DRAINAGE INFORMATION SHEET

PROJECT TITLE Odor Control Station#29 ZONE ATLAS/DRAINAGE FILE # I-14 / D30

RE: FIELD INSPECTION FOR ODOR CONTROL STATIONS 4, 19, & 29
(L-14)

CITY OF ALBUQUERQUE PUBLIC WORKS DEPARTMENT ENGINEERING GROUP					
TITLE: ODOR CONTROL STATION NO. 29					
GRADING & DRAINAGE					
APPROVALS	ENGINEER	DATE	APPROVALS	ENGINEER	DATE
D/R Chair					
Trans. Dev					
Utility Dev					
DRAWING NO.		MAP NO. L-14		SHEET 4 OF 4

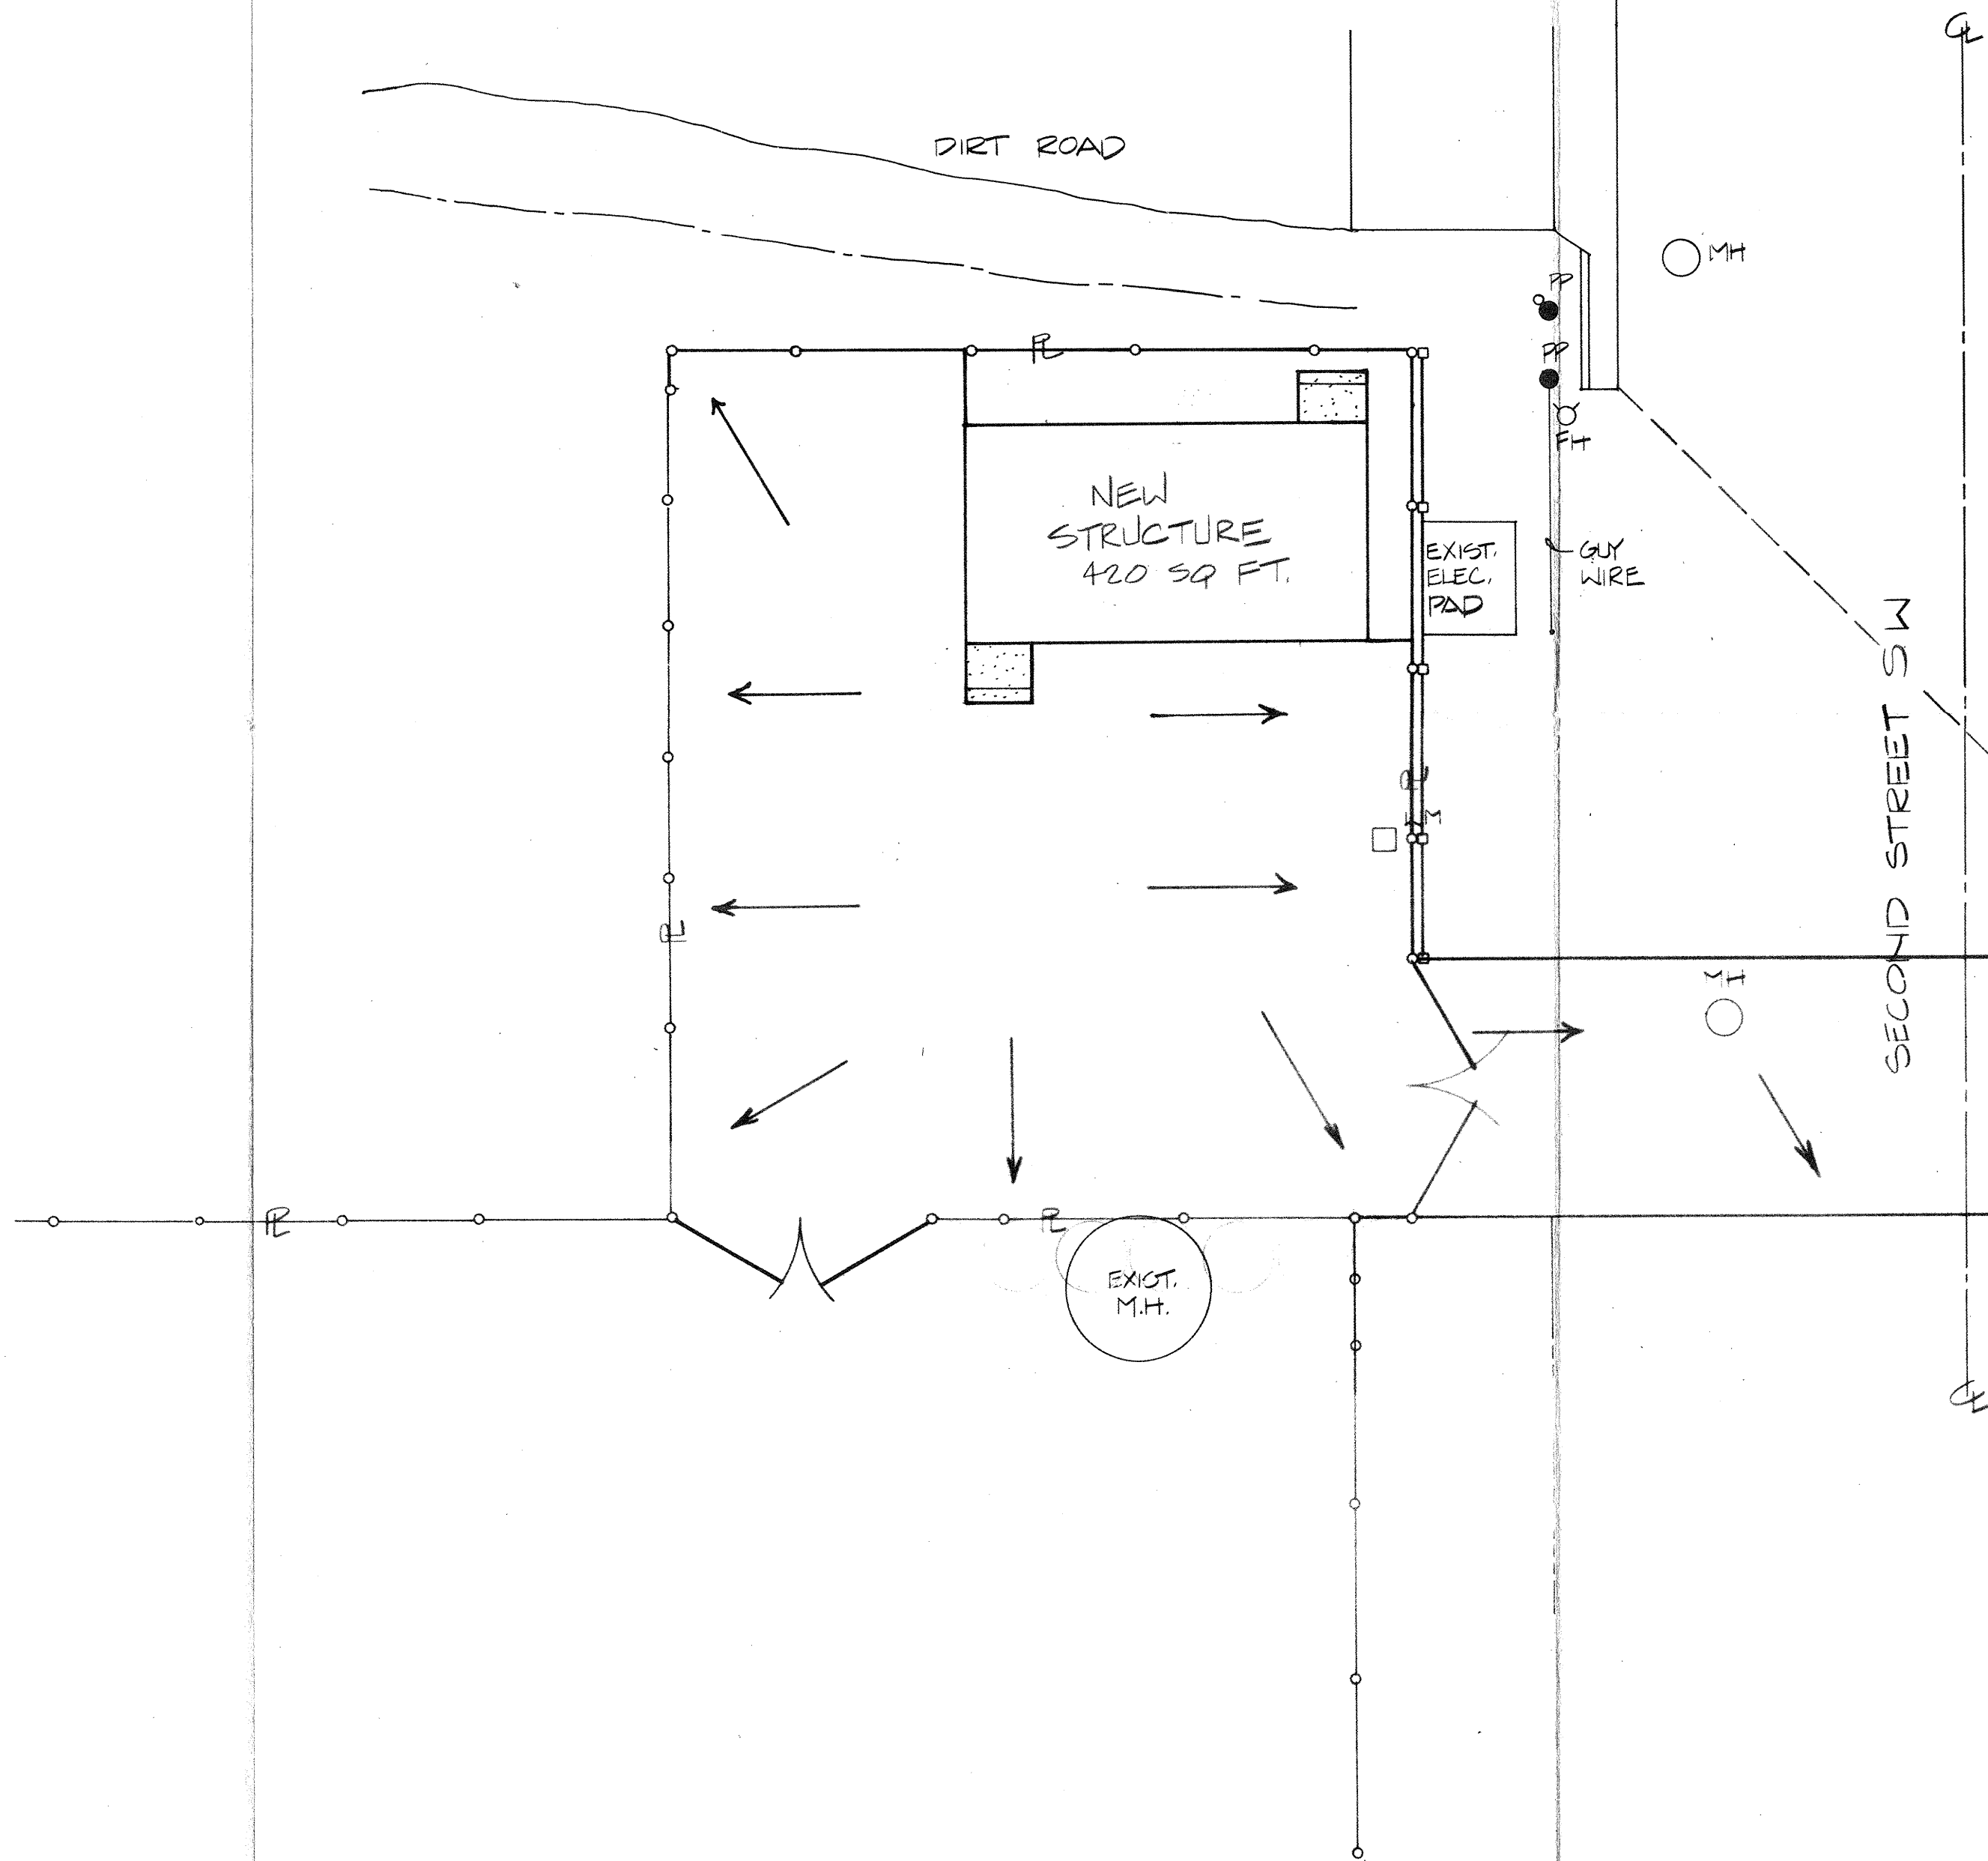
Odor Control Station 29

We will require a drainage plan for this site. Downstream capacity is a problem for this site.
